Relevant Information for Local Planning Panel

FILE: D/2020/55 **DATE:** 2 September 2020

SUBJECT: Information Relevant To Item 3 – Development Application: 29-41 Hutchinson Street, Surry Hills – D/2020/55

Figure 1: View from rear of No. 16 Nichols Street.

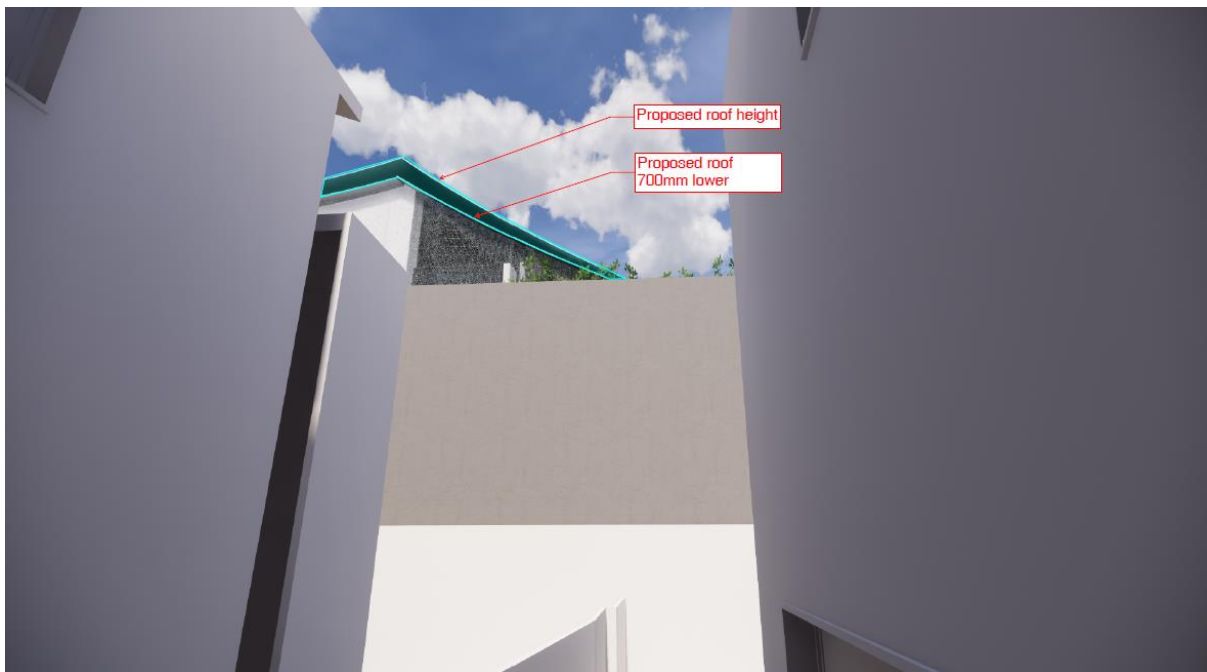
As part of the assessment process the City requested options for lowering the roof pitch along the western boundary. The applicant provided a study for lowering of the maximum ridge height at the western boundary by 700mm. The image below shows a perspective view from the rears of No. 16 and 24 Nichols Street with a comparison between the proposed roof height and pitch lowered by 700mm.

However, the west elevation is the forgotten elevation of the proposal with average height ranges from RL57.41 at the NW corner to RL 60.04 at the highest point. The northern half of this elevation is some 5 metres higher than the eave along the length the southern elevation.

Given the design flexibility of the roof profile, the opportunity is there to lower the eave height along the northern section of the west elevation which would mitigate the amenity impacts.

The reduction in height would reduce usable office floor area and amenity. Given the minimal change to the perceived bulk achieved by the lowering of the roof it was not considered to be required.
